## **REMARKS/ARGUMENTS**

Applicants have studied the Office Action dated May, 12, 2005 and have made amendments to the specification and drawings. The claims have not been amended. It is submitted that the application, as amended, is in condition for allowance. Claims 1-22 are pending. Reconsideration and allowance of the pending claims in view of the following remarks is respectfully requested.

FIG.3

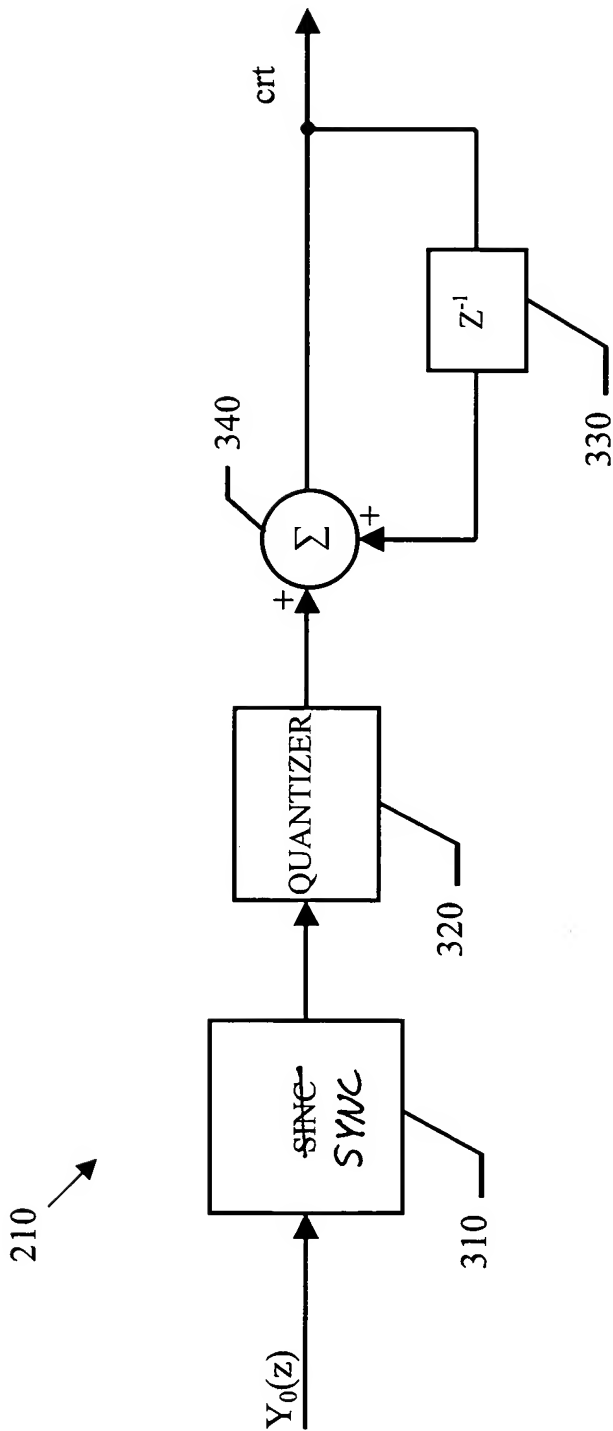
The attached sheets of drawings includes changes to FIGs. 3 & 4. These sheets, which include FIGS. 3 & 4, replace the original sheets. In Figure 3, the word "Sinc" in block 310 has been amended to read "Sync." In Figure 4, the reference number 411 has been added to identify the ellipses shown in the drawing.

FIG.4

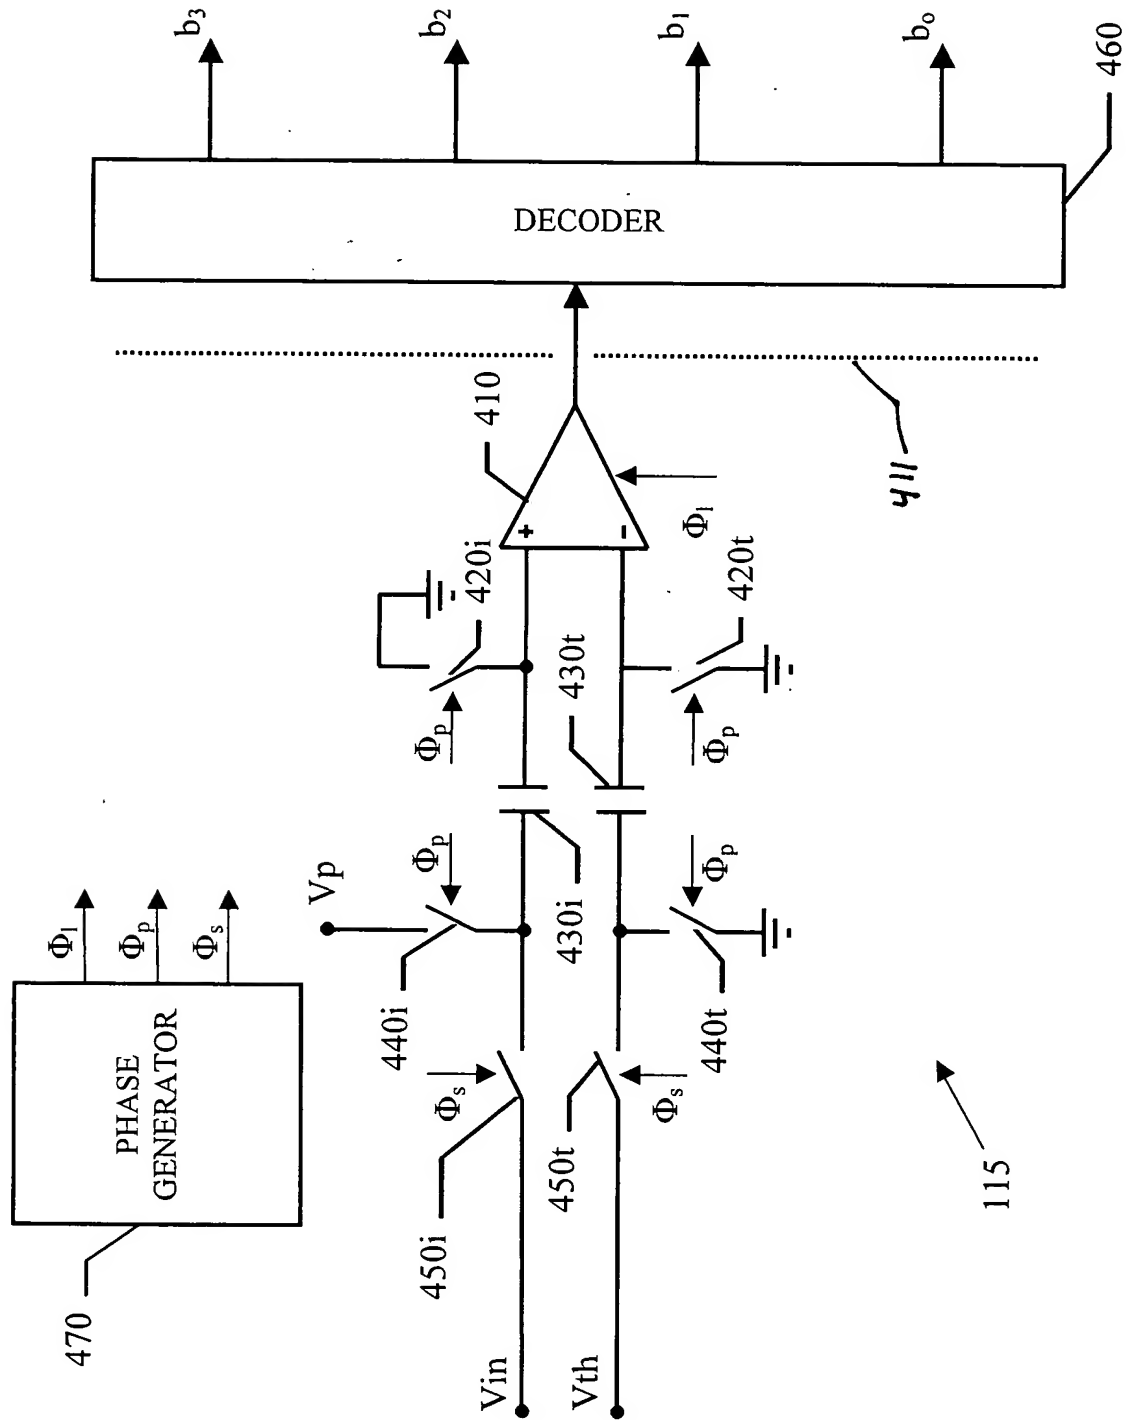
On page 2 of the Office Action, the Examiner requests that FIG. 4 be marked as Prior Art. Applicants respectfully disagree that the FIG. 4 is Prior Art. FIG. 2, which shows a preferred embodiment to the present invention, includes ADC 115. FIG. 4 simply shows a detailed view of inventive element 115, as used in the preferred embodiment, which is shown with multiple inputs, as well as the phase generator 470. It is therefore submitted that the ADC 115, as shown in FIG. 4, is not prior art and the Examiner's objection should be removed.

On page 2 of the Office Action, the Examiner requests that FIG. 4 be amended to show a plurality of comparators 410. FIG. 4, as originally filed, included an ellipsis above and an ellipsis below the comparator 410 indicating a plurality of comparators. FIG. 4 has been amended to identify the ellipses by identification number 411. In addition, the paragraph starting on line 1 of page 14 has been amended to explain that the ellipses are intended to represent a plurality of comparators. It is therefore submitted that the Examiner's objection should be removed.
